RE: DA2018/1820 – 74 Bower St Manly

We are writing on behalf of the owners of 76 Bower St, Manly in regards to a Development Application lodged with Northern Beaches Council for 74 Bower St, Manly

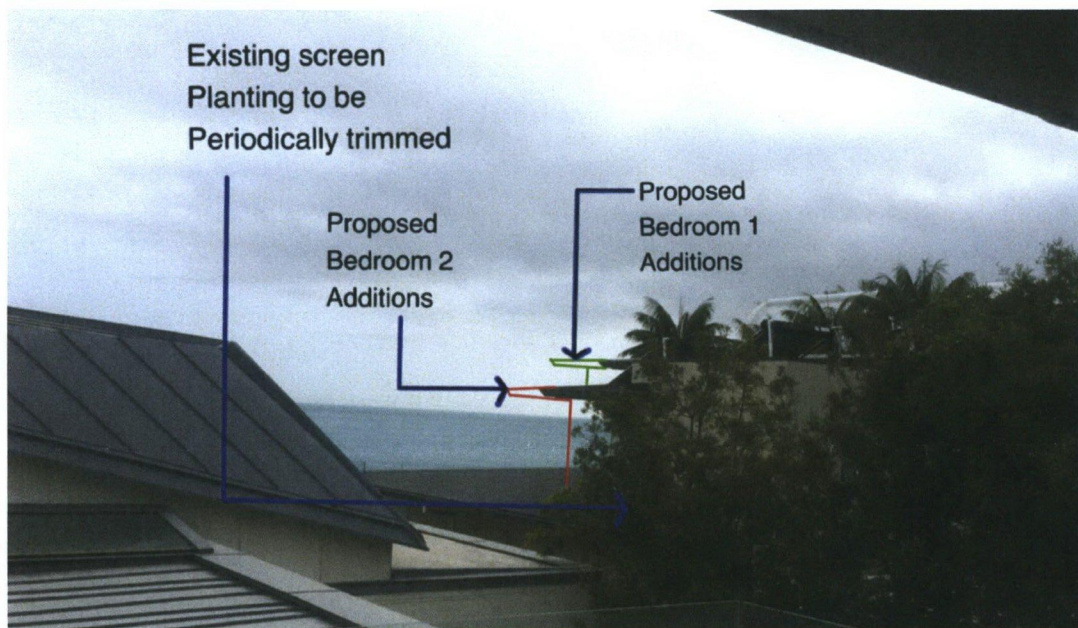
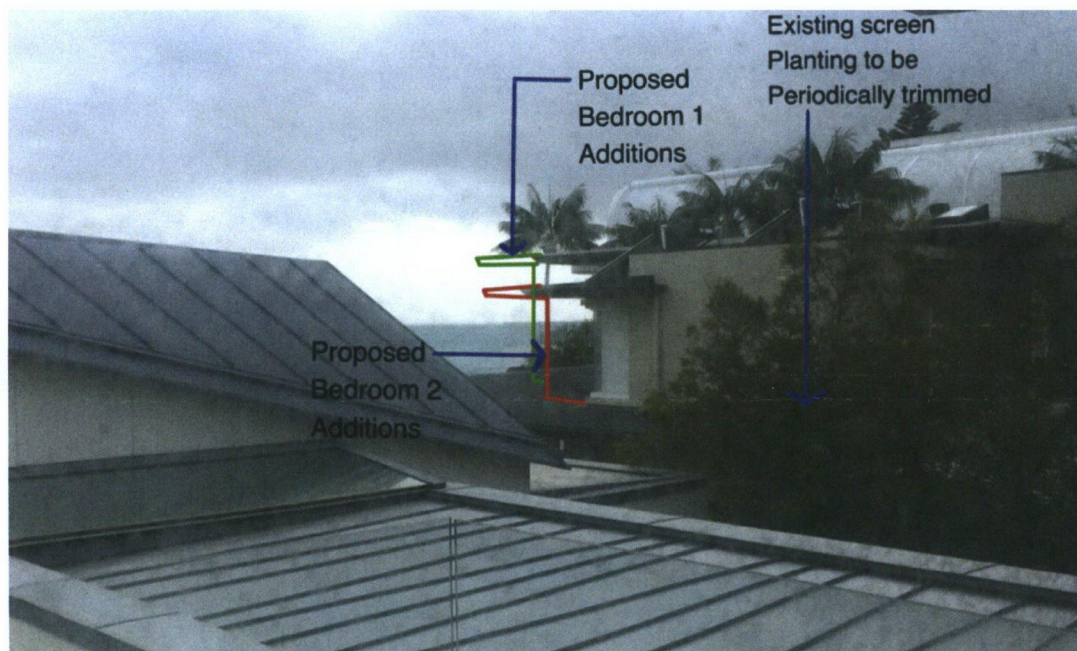
The extension of bedrooms 1 and 2 to the northern elevation results in view loss for our clients from the central balconies and bedrooms on the top floor.

Please find below two photos indicating the impact on views from the two areas of concern.

View from Bedroom 3 balcony (standing position) – 76 Bower St

View from Bedroom 2 (standing position) – 76 Bower St

The views affected to our clients are view currently enjoyed diagonally across the side boundary, from the centre of the site to the rear. The views are from standing positions which should be protected.

As mentioned above, the views affected to our clients are the result of additions that will breach the LEP planning controls for FSR. We would like to note that the existing dwelling on 74 Bower st already breaches the FSR controls by 0.2:1 and the proposed additions will breach the FSR by up to 0.5:1.

The proposed additions are unreasonable in that they will encroach on existing water views by non-compliant additions.

To summarise, we object to the proposed additions and request that the proposal is amended to reduce impacts on the existing amenity enjoyed by our clients.
